ADA Curb Ramp New Construction Inspection Form (Perpendicular)

Nw 294th

23885.56

Nw 293rd

PERPENDICULAR RAMP (PR)

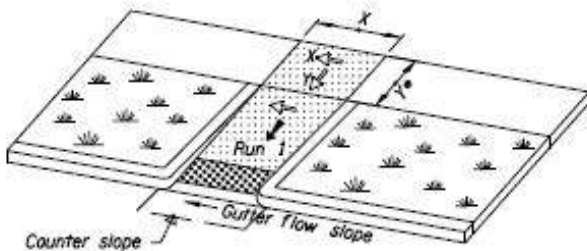
2.4 ≤ 2.0% ☐ >2.0% ☒

IITD RR 1 Fails
